UNITED STATES PATENT AND TRADEMARK OFFICE

APPLICATION NO.	FILING DATE	FIRST NAMED INVENTOR	ATTORNEY DOCKET NO.	CONFIRMATION NO.
10/532,402	04/22/2005	Marko Siebert	BM-168PCT	9126
40570	7590	11/02/2006	EXAMINER	
FRIEDRICH KUEFFNER 317 MADISON AVENUE, SUITE 910 NEW YORK, NY 10017			KENNY, DANIEL J	
			ART UNIT	PAPER NUMBER
			3637

Office Action Summary

Annotated Fig. 5 (U.S. Pat. 5,679,419)

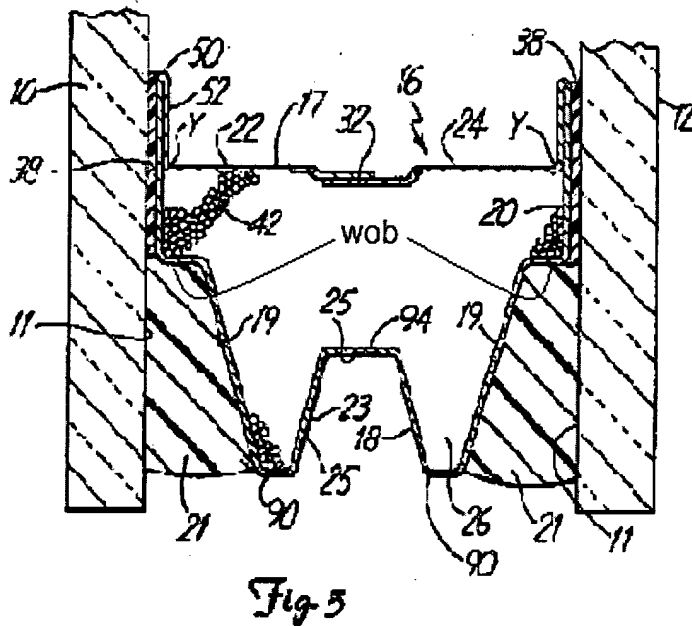
Larsen discloses a spacer (S) comprising a generally rectangular open space (Larsen comprises a generally rectangular open space as broadly recited) filled with moisture-absorbing material (42); said open space bounded by side walls (20), a rear wall (94), and an inner wall (17); said spacer rear wall having two webs (19) inclined towards each other and projecting from the rear wall in the direction opposite the open space, the space created between the webs and the panes capable of being filled with sealant (21); and the two portions of the wall (wob) outside the bounds of the two webs lying on a different plane (lower or otherwise) than the portion of the wall (25) inside said bounds.

Larsen does not disclose parallel webs.

Fratti et al. discloses a spacer (120) having parallel webs (122).

It would have been obvious to one of ordinary skill in the art at the time the present invention was made to include the parallel webs as in Fratti et al. in the structure of Larsen to provide a uniform sealant thickness.

Annotated Fig. 12 (German reference 2,224,264)

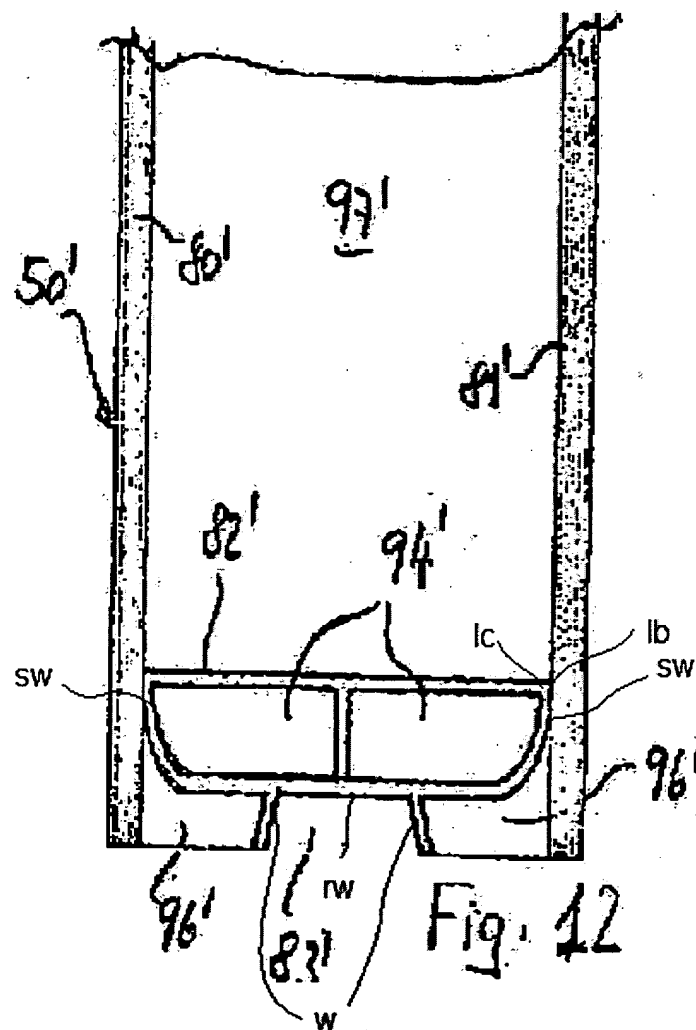
Larsen discloses all the claimed limitations as described above. Larsen does not disclose the lower corner of the side wall forming a lower boundary of the sealant space.

German reference 2,224,264 discloses a spacer having webs (w) wherein the lower corner (lc) of the side wall (sw) forms a lower boundary (lb) of a sealant space (96').
